NL-13-1734

Joseph M. Farley Nuclear Plant – Units 1 and 2  
Southern Nuclear Operating Company Response to the  
Request for Additional Information Regarding Overall Integrated Plan for  
Reliable Spent Fuel Pool Instrumentation (Order Number EA-12-051)

**Southern Nuclear Operating Company Response to the Request for Additional  
Information Regarding Overall Integrated Plan for Reliable Spent Fuel Pool  
Instrumentation (Order Number EA-12-051)**

SKETCH IN RESPONSE TO RAI ITEM 1b

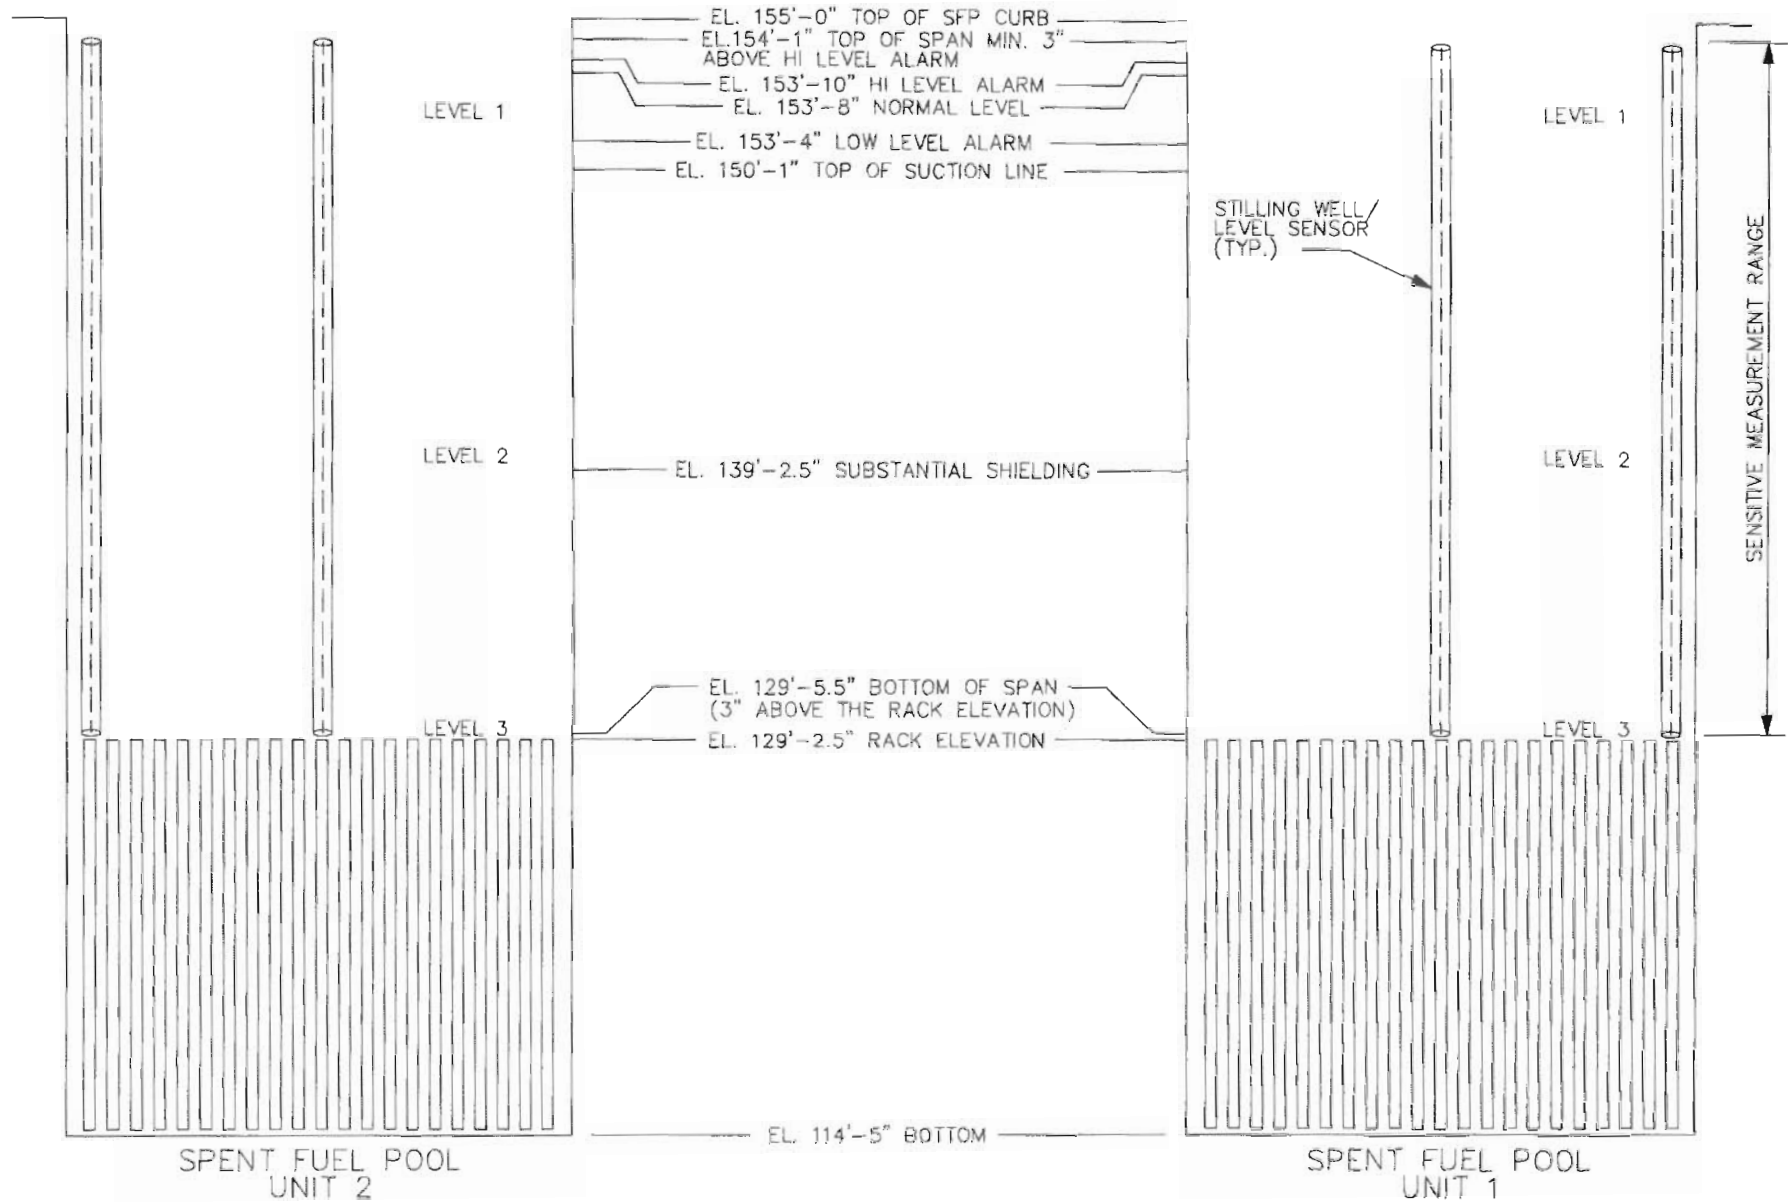
- a) For Level 1, specify how the identified location represents the HIGHER of the two points described in the NEI 12-02 guidance for this level.
- b) A clearly labeled sketch depicting the elevation view of the proposed typical mounting arrangement for the portions of instrument channel consisting of permanent measurement channel equipment (e.g., fixed level probes and/or stilling wells, and mounting brackets). Indicate on this sketch the portion of the level sensor measurement range that is sensitive to measurement of the fuel pool level, with respect to the Level 1, Level 2, and Level 3 datum points.

Enclosure 2 provides a sketch that depicts an elevation view of the Unit 1 and 2 SFP. The sketch depicts the datum values representing Level 1, Level 2, and Level 3. Per NEI 12-02, Level 3 corresponds nominally (i.e., +/- 1 foot) to the highest point of any rack seated in the spent fuel pool. The level sensor sensitive measurement range will span from a minimum of 3 inches above the high SFP level alarm setpoint to 3 inches above the top of the spent fuel pool rack.

Farley Unit 1 Spent Fuel Pool Potential Probe Mount Locations (Part of Drawing D-176708)

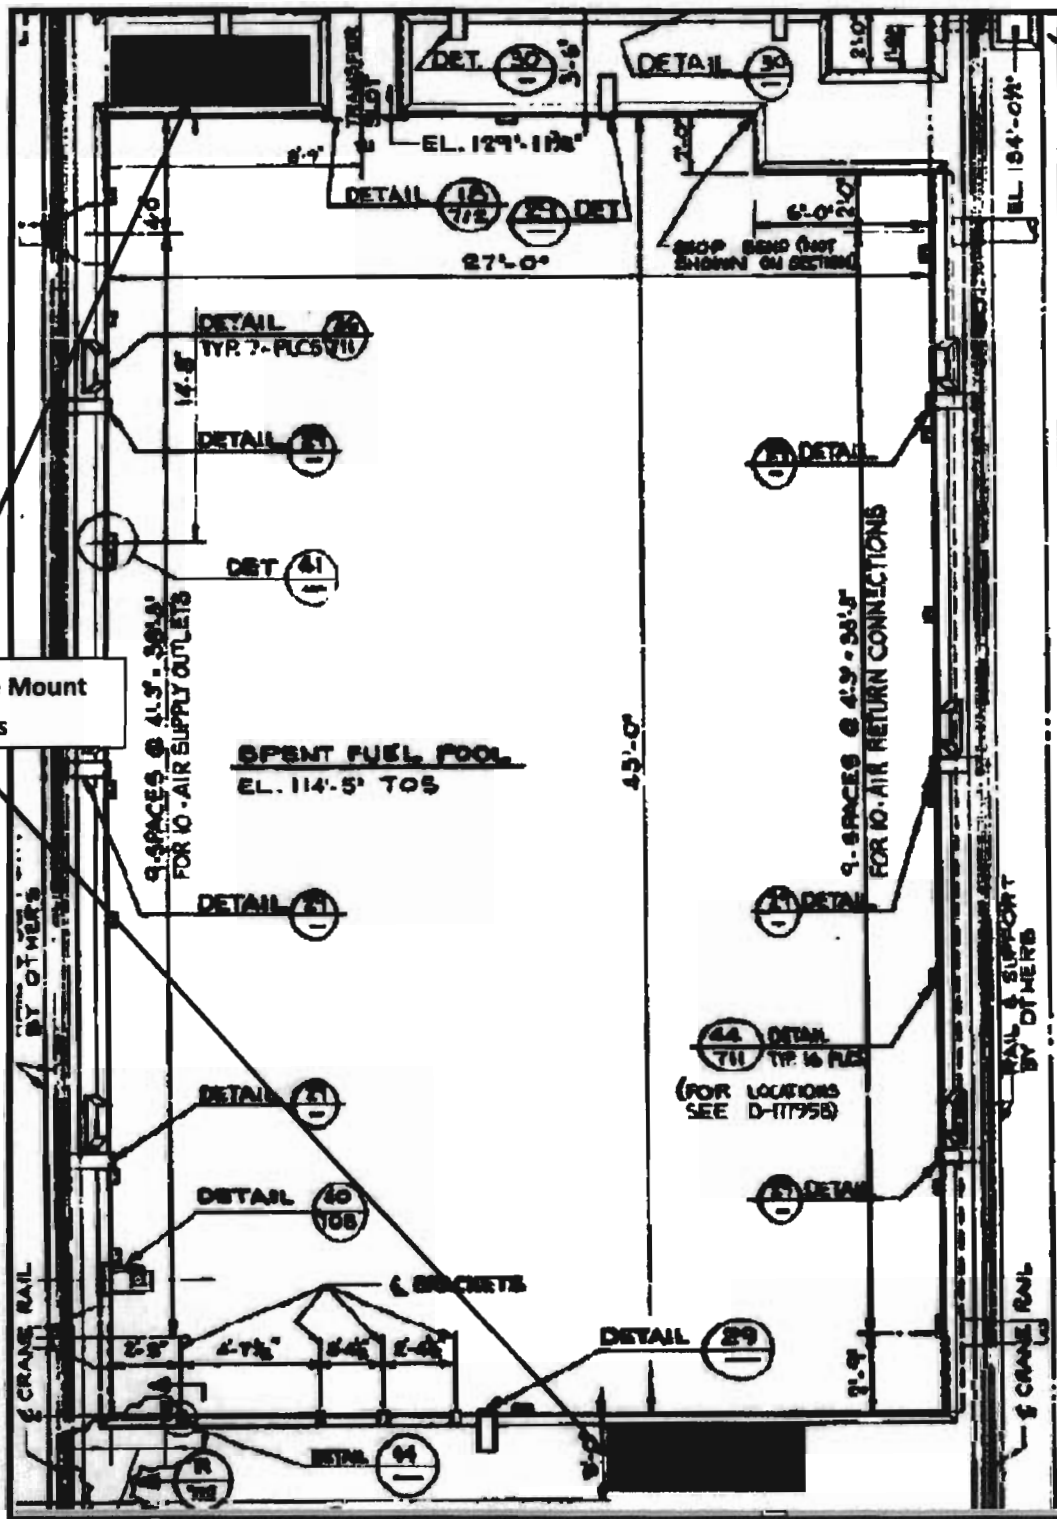
Provide a clearly labeled sketch or marked-up plant drawing of the plan view of the SFP area depicting, in addition to the planned locations/placement of the primary and back-up SFP level sensors provided in Attachment 1, the SFP inside dimensions and the proposed routing of the cables that will extend from the sensors toward the location of the read-out/display device. Further, confirm that proposed area(s) will be accessible when the SFP area is not accessible.

Enclosure 3 depicts a section of marked up plant drawings D-176708 and D-206708. This enclosure shows a plan view of the SFP area of each unit. The drawings show inside dimensions (45 feet long by 27 feet wide (nominal)) for the SFPs and the anticipated areas for locating level sensors. There is no designated primary or backup sensor as both serve an equal purpose. The routing of the instrument cables from the sensors to the display device will be determined after a location for the display unit has been finalized. The probe, mount, and cable, will not be accessible when the SFP area is not accessible. The electronics package and display will be accessible and habitable via non-heroic means during the response to event as required even when the SFP area is not accessible and habitable. SNC intends to provide in the February 2014 Overall Integrated Plan 6 month update information concerning specific SFP area cable routing.
